County of Loudoun

MEMORANDUM

SUBJECT: ZMAP 2008-0023, Cedar Green Church, 2nd Referral

Concept Plan Excerpt (January 2, 2009)

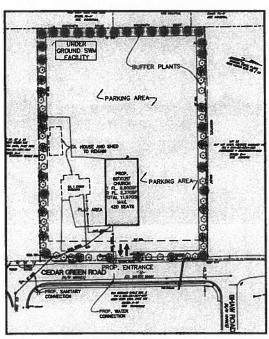
The proposed concept plan centers the church on the street frontage. The church is set back approximately 62 feet from the front property line. A vehicle entrance is placed directly in front of the church.

Staff recommends that the applicant provide further details regarding vehicle circulation with clearly defined entrance lanes, curbs, sidewalks, and drop-off points, as applicable, so that the streetscape can be evaluated. The applicant should consider relocating the entrance driveway further to the north, to enhance the views of the church from the street and the surrounding community. Street tress should be placed to create an overhead leaf canopy for Cedar Green Road. The applicant should also consider gateways, walls, enhanced plantings, or other design elements along the Cedar Green Road frontage.

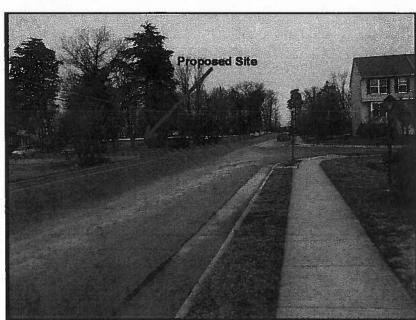
The applicant has designated an area in the southwest corner of the site as an underground stormwater management facility but has not provided any further details regarding water quality and quantity controls. Staff notes that a curb and gutter system has been installed on the east side of Cedar Green Road.

Staff recommends that the applicant consider employing LID facilities on-site. Staff recommends water treatment measures that mimic the pre-development conditions of the site, mitigate impacts to the watershed, and treat the stormwater runoff as an amenity. The applicant should consider various site measures, such as permeable pavers, porous concrete, cisterns, planted swales, curb cuts, rain gardens, and bioretention filters adjacent to impervious areas, to promote infiltration on-site, minimize peak storm flows, and help filter non-point source pollutants. Pipe installation should be minimized.

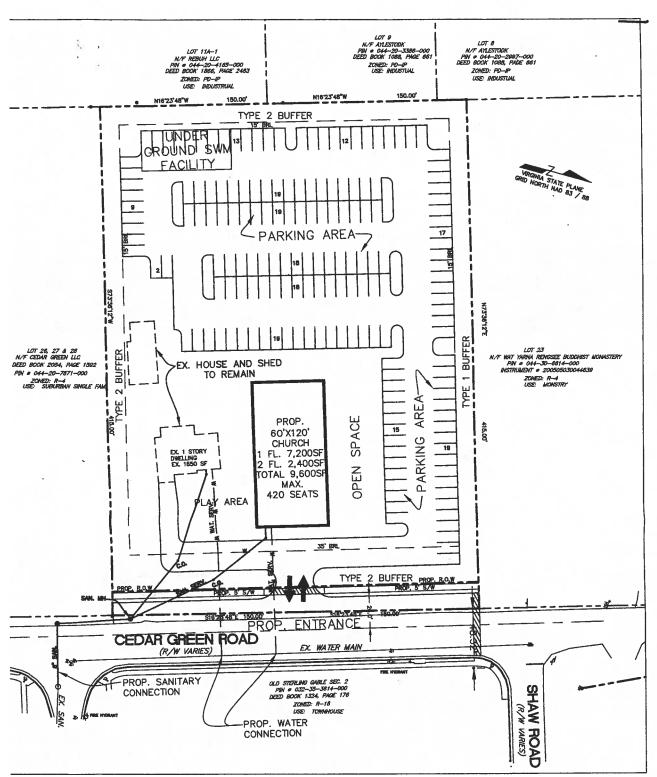
4. On June 2, 2009, the Board of Supervisors passed a resolution (provided as Attachment 2) indicating its preference regarding the alignment of the future east-west segment of Shaw Road in the Belfort Park area. The Board's resolution calls for a two-lane (U2) road section within a 50-foot ROW extending west from the current east-west Shaw Road alignment, which would place the road along or just north of the site's northern boundary. This location has been included on the current draft of the Countywide Transportation Plan currently under review by the Planning Commission. Given this alignment, OTS staff suggests that the Applicant consider designing its proposed parking area (in the northwest).

corner of the site) to accommodate a future ingress/egress access point to this future road.
